NUREG-xxxx

**United States  
Nuclear Regulatory  
Commission  
Spent Fuel Transportation  
Risk Assessment**

**Draft Report for Comment**

Figure 1-2. NAC-STC cask (courtesy of NAC International)

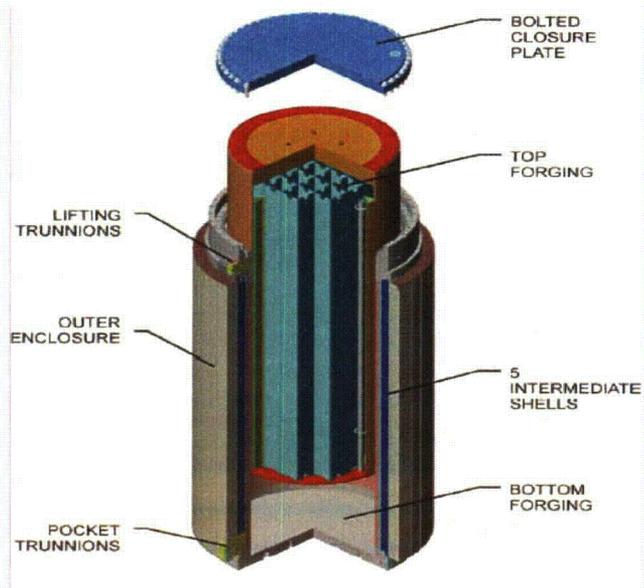
**Comment [csb30]:** You may want to label this diagram. Obviously this is a rendering perhaps a shot from an analysis model...it may not be clear exactly what it represents.

Figure 1-3. Basic layout of the HI-STAR 100 rail transport cask (from Haire and Swaney, 2005, and Holtec International, 2004)

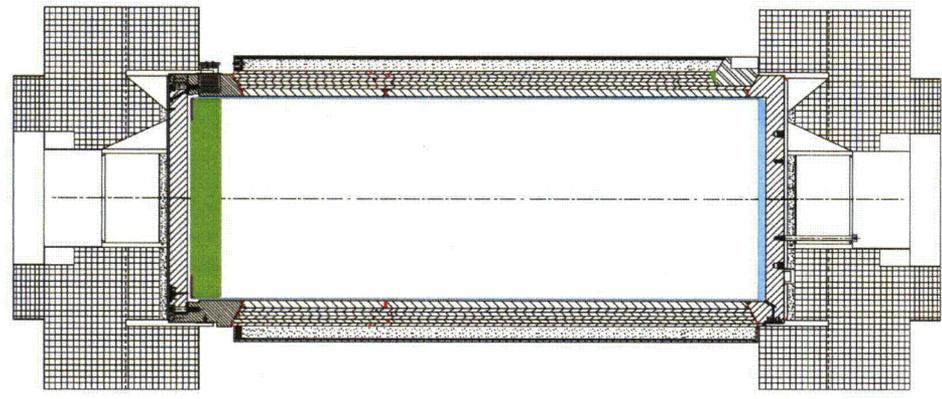
Comment [csb31]: Add not: with impact limiters removed
